Access Compliance Report

Public Rights-of-Way

(Curb Ramps)

Intersection ID: 20138	Main Street: ARBOR_WY	Cross Street: STEDWICK_PL	Location:	N
ADA ID: D1ED34089F68	Ramp Type: BlendTrans1	Initial Pass/Fail: Fail	Overall Compliance: No	Severity Score: 10
Codes/Mitigation Info/Possible Solution		Field Measurements/Component Compliance

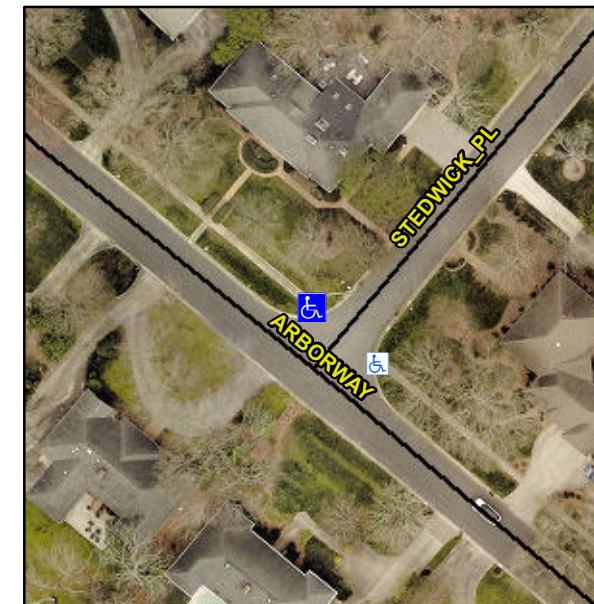
Not Found, R304.5.1, R304.5.3

Compliance	Description	Data	Compliance	Description	Data
N/A	Ramp Length (in)	53.0	Yes	BlendTrans Slope (%)	4.8
No	Ramp Width (in)	47.0	No	BlendTrans XSlope (%)	2.3
N/A	Flare Type LT	N/A	N/A	Flare Type RT	N/A
N/A	Flare Slope LT (%)	N/A	N/A	Flare Slope RT (%)	N/A
N/A	Flare Traversable LT?	N/A	N/A	Flare Traversable RT?	N/A
N/A	Landing Length (in)	N/A	N/A	DWS Provided?	N/A
N/A	Landing Width (in)	N/A	N/A	DWS Contrast?	N/A
N/A	Landing Slope (%)	N/A	N/A	DWS Length (in)	N/A
N/A	Landing X Slope (%)	N/A	N/A	DWS Full Width?	N/A
N/A	Landing Curb? (Y/N)	N/A	N/A	DWS Offset (in)	N/A
N/A	Shared Landing?	N/A			
N/A	Gutter Ponding?	N/A	N/A	Gutter Slope (%)	N/A
N/A	Gutter Lip Ht (in)	N/A	N/A	Gutter X Slope (%)	N/A
N/A	Painted X Walk1?	No	N/A	Painted X Walk2?	No
	X Walk 1 Direction	To SW		X Walk 2 Direction	To SE
	X Walk 1 Width (in)	N/A		X Walk 2 Width (in)	N/A
	X Walk 1 Slope (%)	0.6		X Walk 2 Slope (%)	4.1
	X Walk 1 X Slope (%)	0.7		X Walk 2 X Slope (%)	1.9

N/A	Ramp inside XWalk1?	N/A	N/A	Ramp inside XWalk2?	N/A
	Road Slope (%)	3.2		Clear Space?	N/A
	Road X Slope (%)	2.7	N/A	Clear Space to XWalk (in)	N/A
N/A	Any Obstructions?	N/A	N/A	Storm Grate/Utility Hazard?	N/A
	Obstruction Type			Storm Grate/Utility Type	
		N/A			N/A
			Yes	Surface Condition? (G/P)	Good
			No	Curb Slope (%)	19.5

Remove & Replace Curb Ramp With Two New Directional Ramps or Equivalent.
